PROJECT INFORMATION		DOCUMENTS FOR REVIEW AND FILES LOCATION		TIME LINES
Proj. Name and Number:	Arlington STP BP17(2)	PLANS	FILE LOCATION : Z:\Highways\MUN\LCL\LTF Projects\Arlington STP BP17(2)\3 Conceptual\Plans\Arlington STP BP17(2) Concept Plans 083018	SUBMITTED: 09-07-2018
EA No.: BP17002	PPMS: 17F243	ESTIMATE	FILE LOCATION : Z:\Highways\MUN\LCL\LTF Projects\Arlington STP BP17(2)\3 Conceptual\Documents\Conceptual Estimate\Arlington STP BP17(2) Conceptual Cost Estimate	
Project Manager: Jon Kaplan			FILE LOCATION :	
Program: Municipal Assistance	Phase: Conceptual		FILE LOCATION :	DEADLINE: 09-28-2018
District: District 1	If Multiple Districts Specify		FILE LOCATION :	COMPLETED: 10-02-2018
Traffic Signal: Yes			FILE LOCATION :

PLANS FOR CONSTRUCTION OF RECREATION PARK PEDESTRIAN ACCESS ARLINGTON, BENNINGTON COUNTY, VERMONT

ARLINGTON STP BP17(12)

### SITE PLAN AND PROFILE STA 6+00 TO 12+00

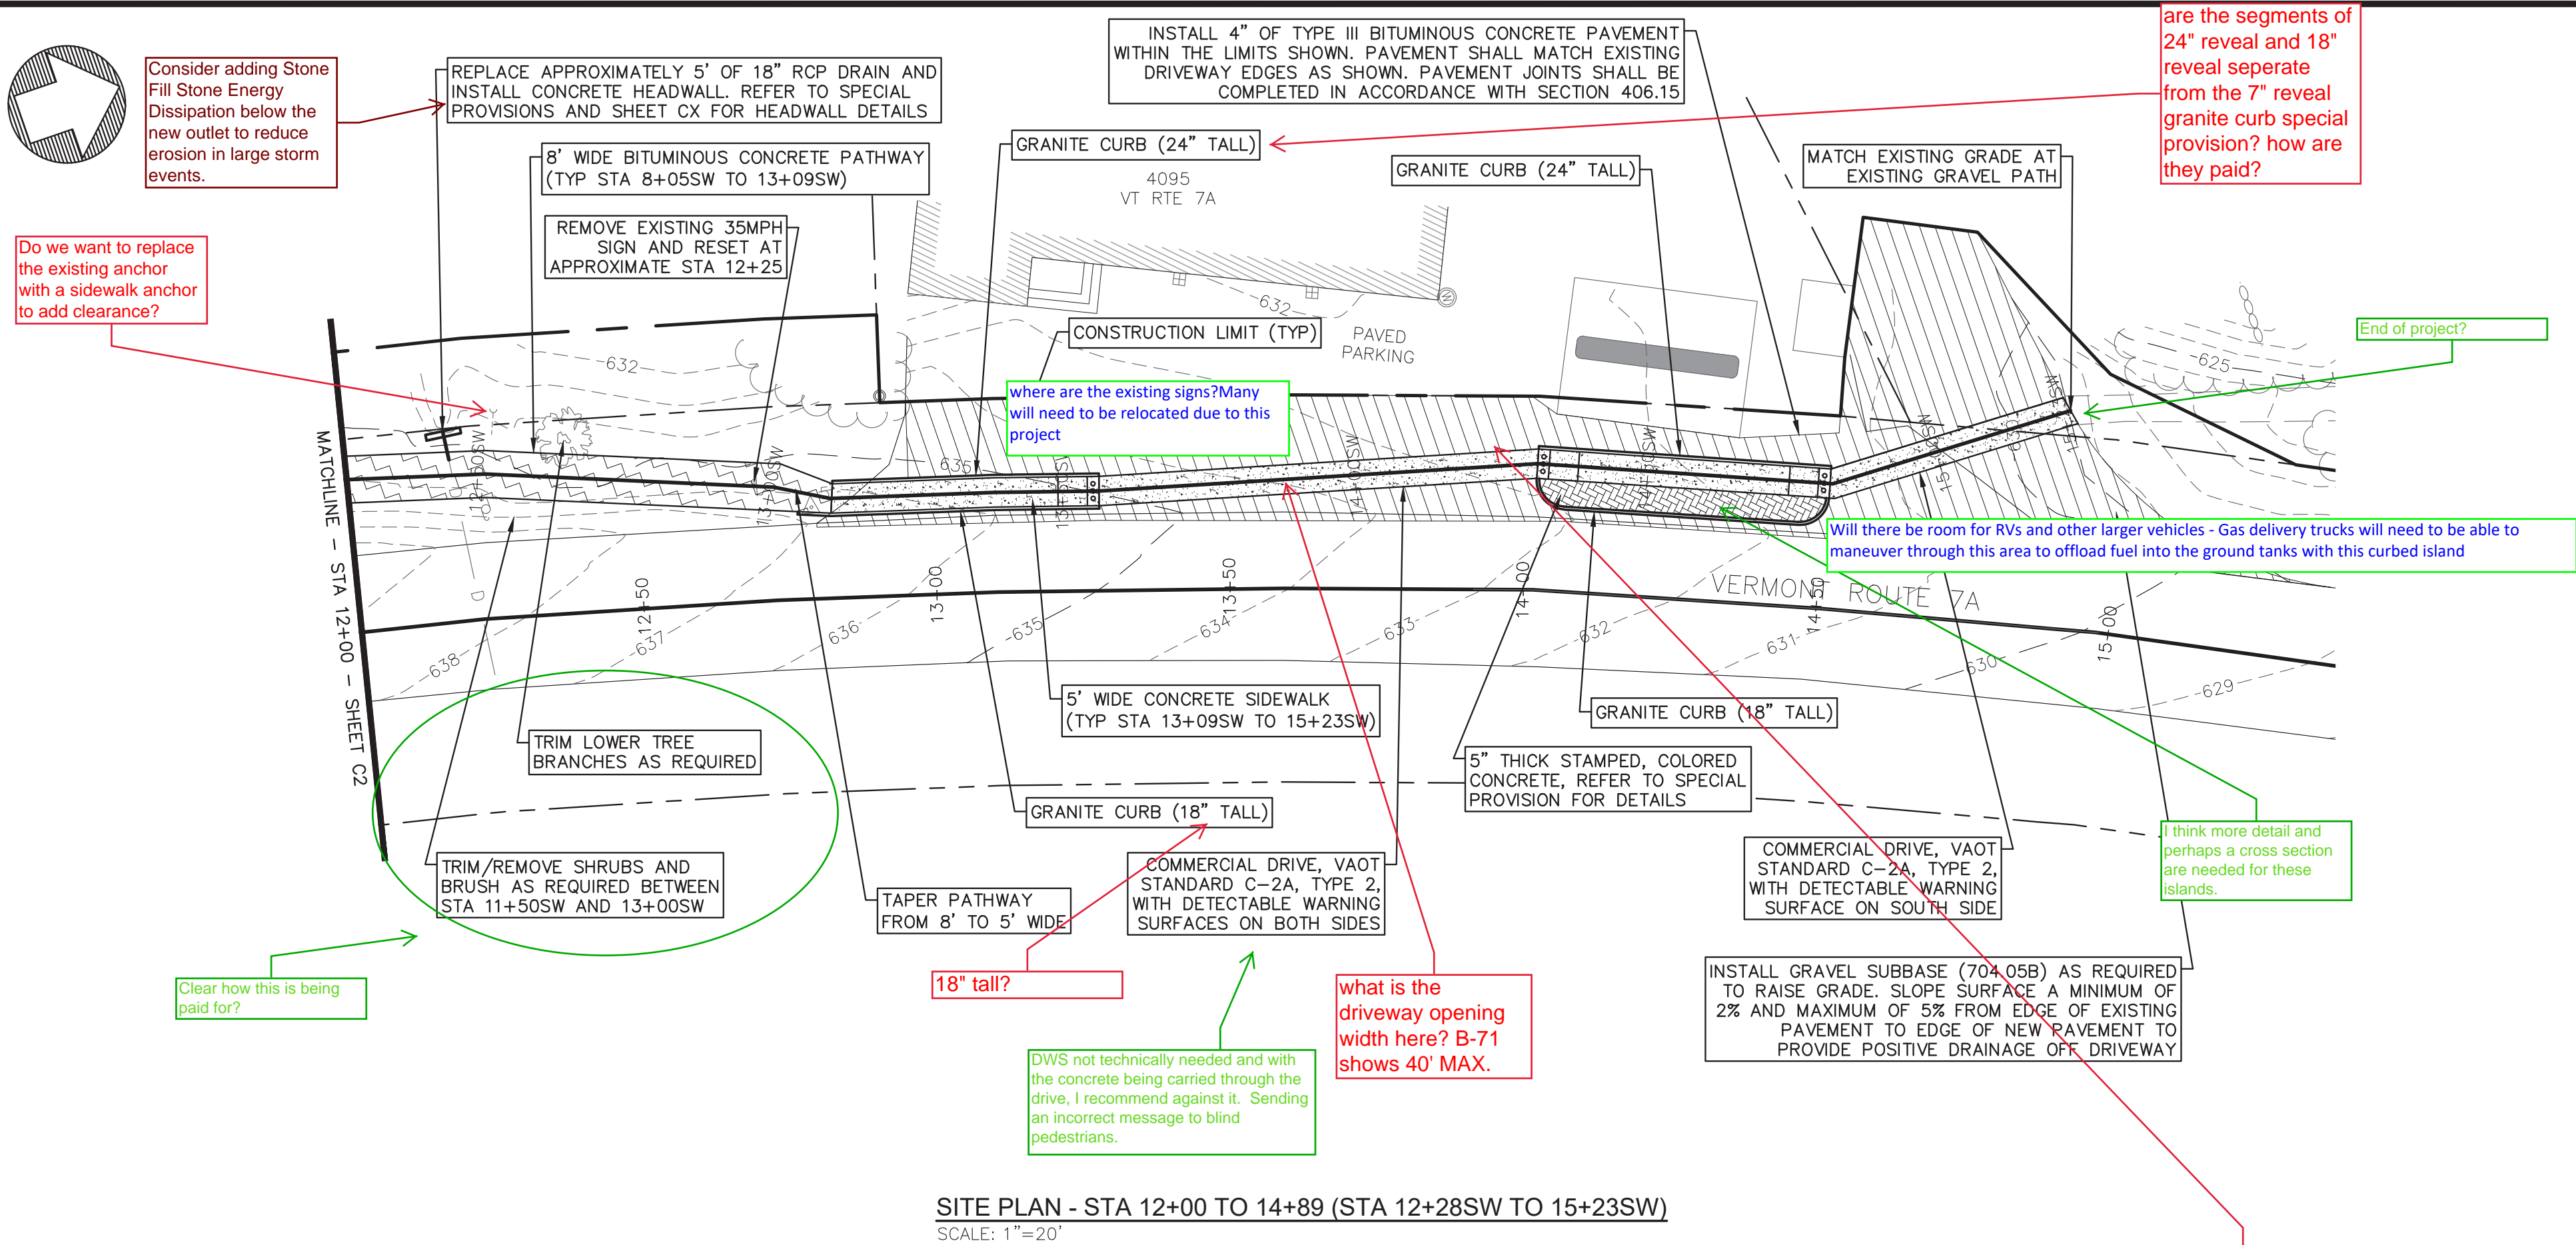
Consider adding Stone Fill Stone Energy Dissipation below the new outlet to reduce erosion in large storm events.

are conflicts with roots anticipated? excavation is deep here

where are the existing signs? Many will need to be relocated due to this project

Did you assess the condition of this existing pipe?

Does this crossing meet mid-block crossing warrants? What is the need for the RRFB? Over use of these devices breeds contempt for crossing and motorist ignoring them altogether.

Is there still a "JCT 313" sign @ this approx. location?

callout tree species and size, this will help bidders understand the requirements of placing sidewalk against the root systems.

- The location of crosswalk may want to be reevaluated - sight distance may be okay but its location in front of a house (w/parking on the shoulder) may lend itself to problems. Has alternative crosswalk locations been ruled out?
- Access management in front of the house at this location should be applied.
- Why is the ROW only three rods at this house? Boundary pins may be set at this location; however, this will need to be further evaluated by our ROW section - what is the basis for the surveyor's determination?

Highly recommend against RRFBs with a new crosswalk. AADT is just over the threshold of installing a marked crosswalk. This reviewer's opinion is that RRFBs are overused and should be reserved for crosswalks with higher AADTs and a troublesome history.

Extensive vegetation removal will need to be done on inside of curve to increase visibility to easterly end of crosswalk.

SITE PLAN - STA 12+00 TO 14+89 (STA 12+28SW TO 15+23SW)  
SCALE: 1"=20'

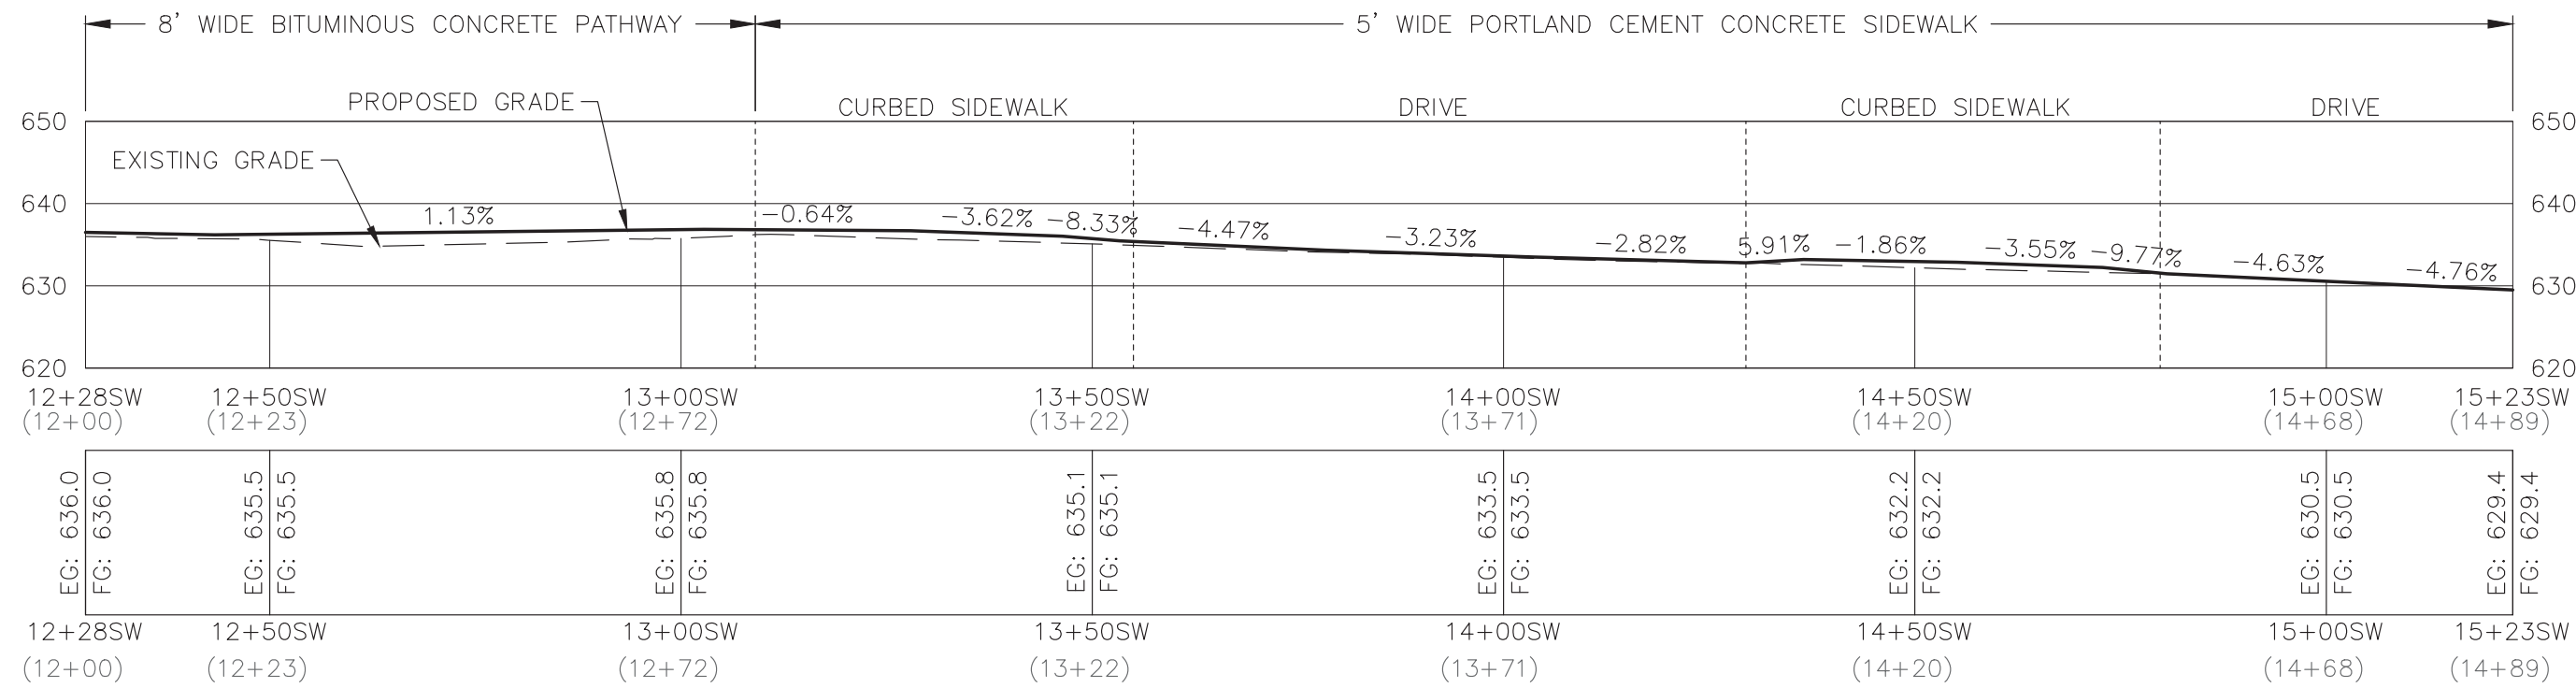
- Jogs and shifts in walk/path are not desirable, how can this be remedied?
- Shift in widths is not desirable, why is this going back and forth from 5 to 8 ft?

- Raised 5' walk with no green space with added jogs can cause some concerns for younger users, particularly with the curb/sidewalk edge close to the edge line on the outside of a curb - can/how can this be rectified?

- Be sure all curbed areas have the 15' offset from center line for maintenance.
- Project stops short of designation point, at project terminus the path in no longer ADA compliant, should it be? If not, how will users alternately access the recreation field?

- All the work in the area of this parcel appears to be within the State ROW (4-rods), work within this segment may not need property rights or owners approval; however, a full evaluation of access needs and circulation (turning movements) should be evaluated and considered an access management proposal (Chris has already suggested this to the consultant).

### PORTLAND CEMENT CONCRETE SIDEWALK DETAIL

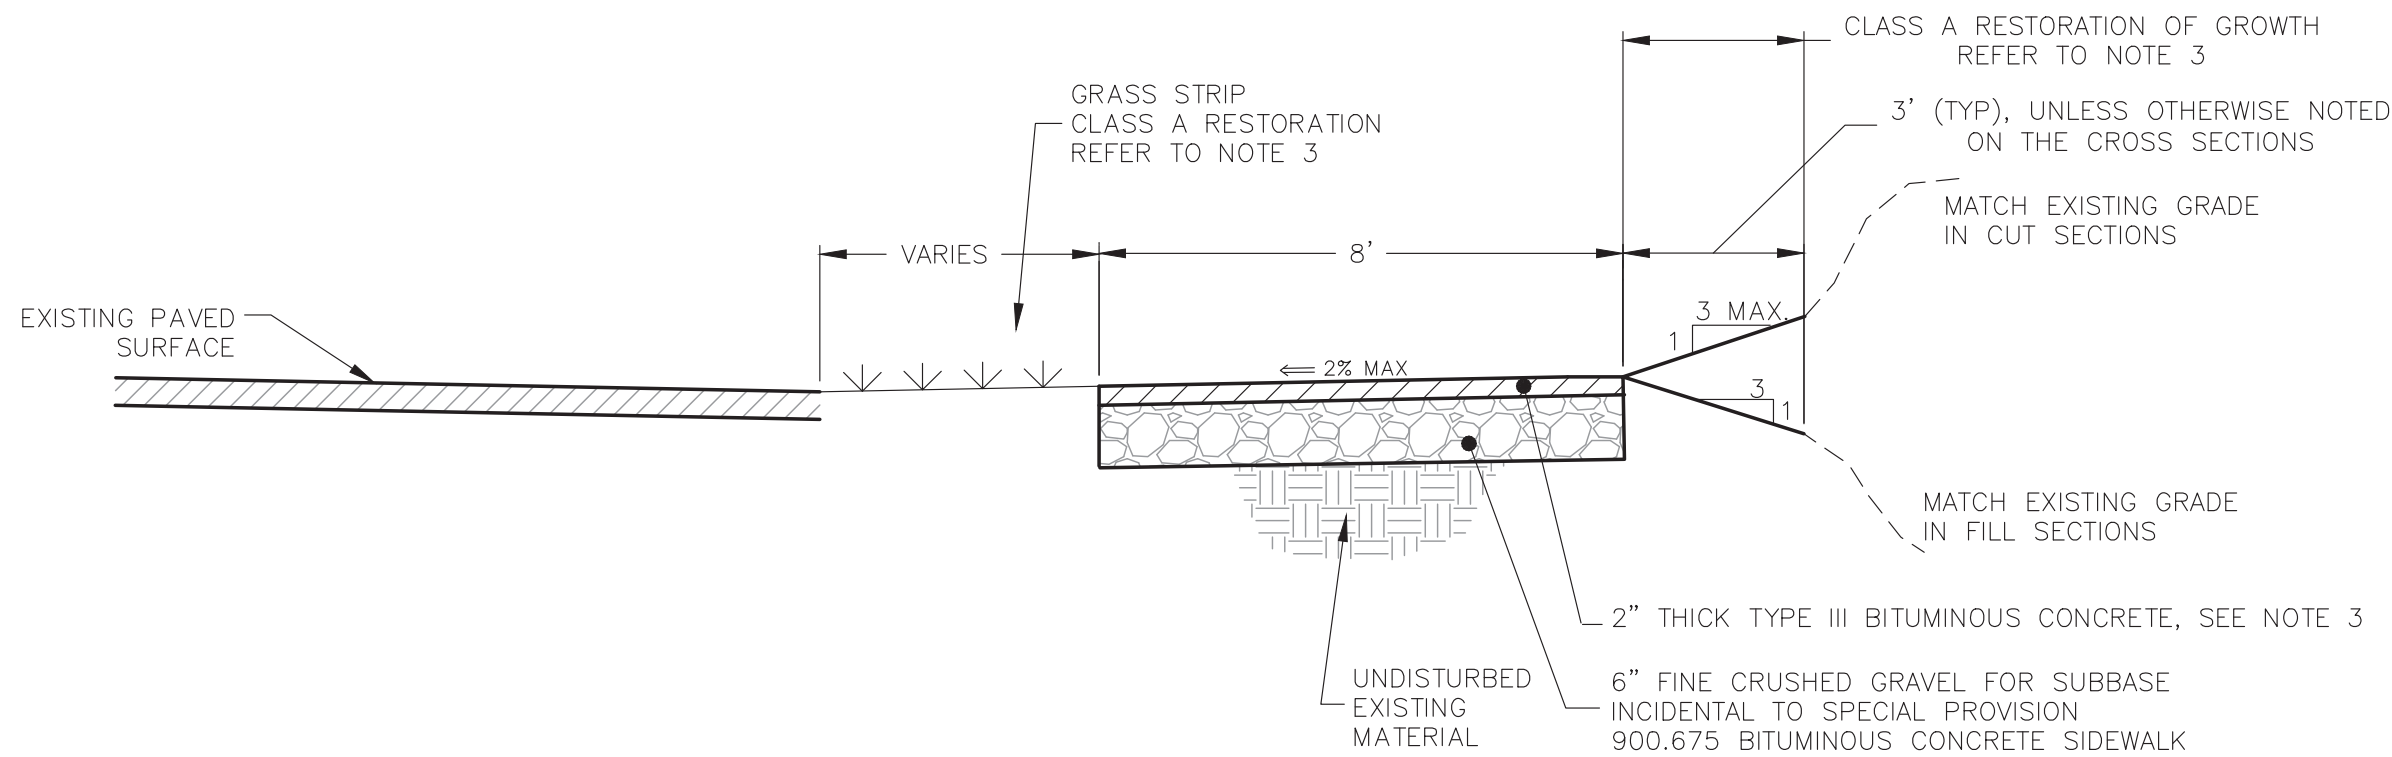
Does this mean two lifts? No max thickness? Could do one of 10" and one of 2" as written.

is this necessary? adds cost, needs to meet buy america provisions etc... is there a compelling reason to do this?

square up this detail and show clear limits - show as close to reasonable how it will be constructed.

### JOINT DETAIL A

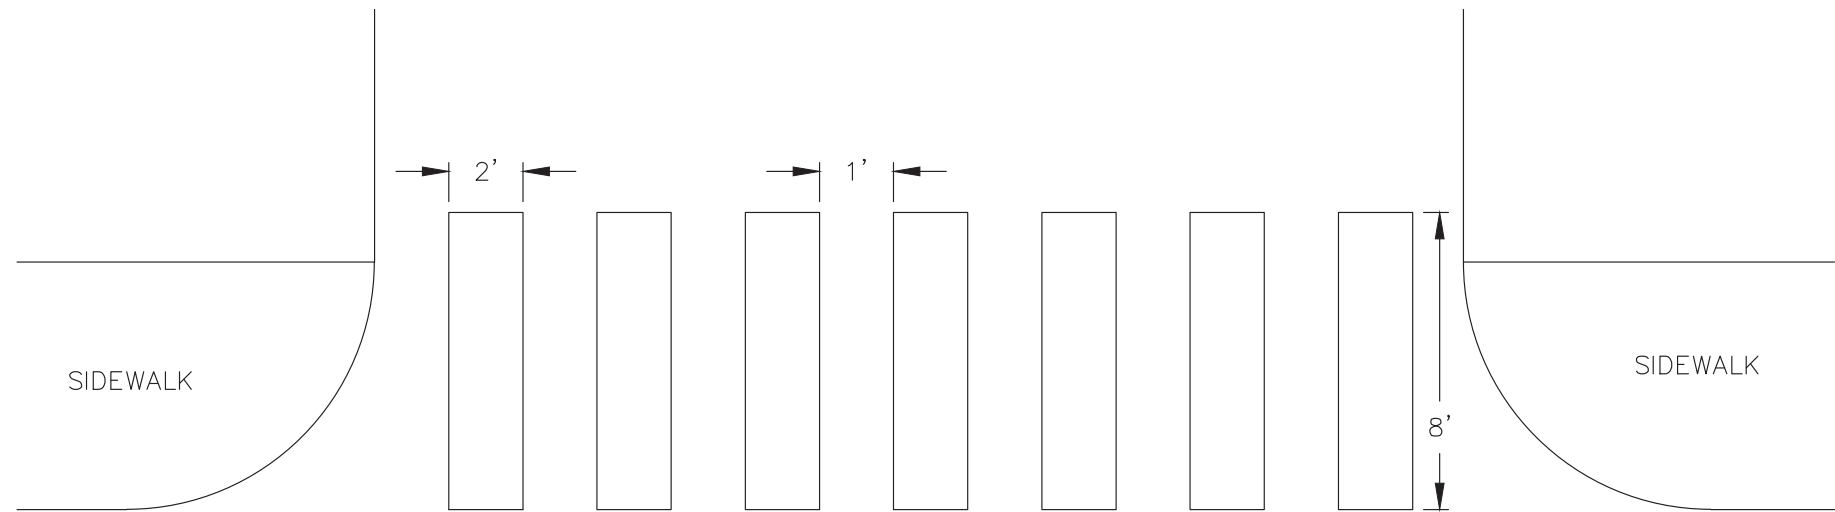
with the proximity to some trees, 12" will be harder to achieve without major disruptions to roots.

Does this note work with welder wire reinforcement?

### BLOCK PATTERN CROSSWALK

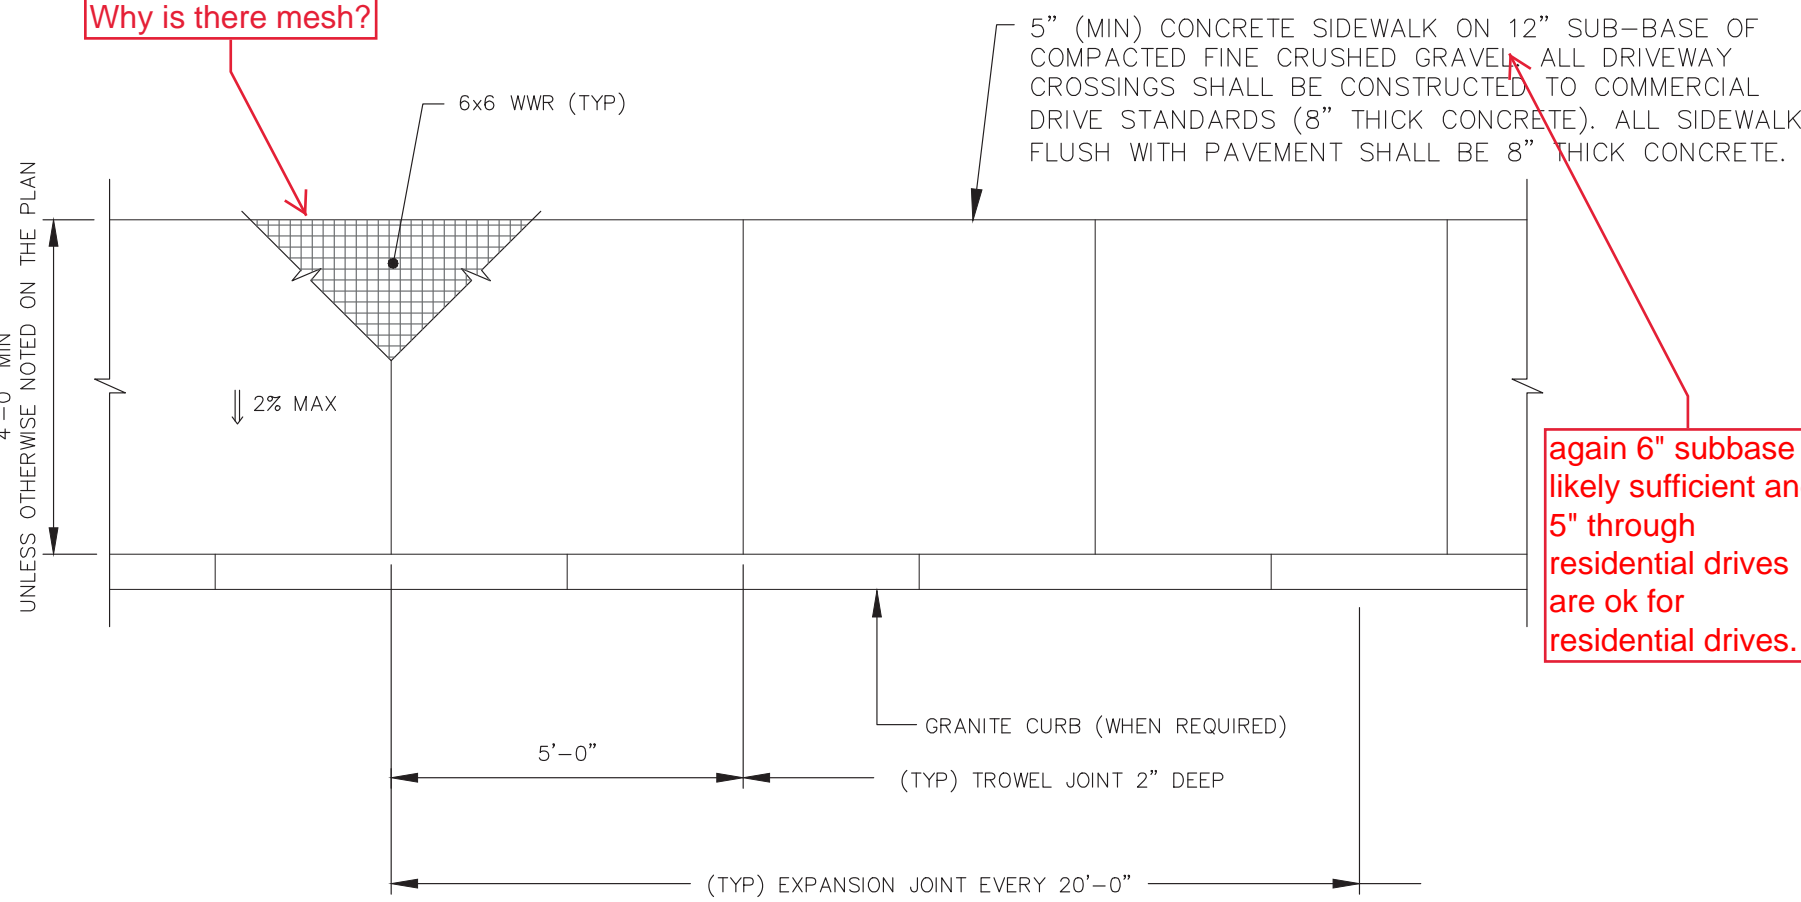
how far from outside edge? please be more specific
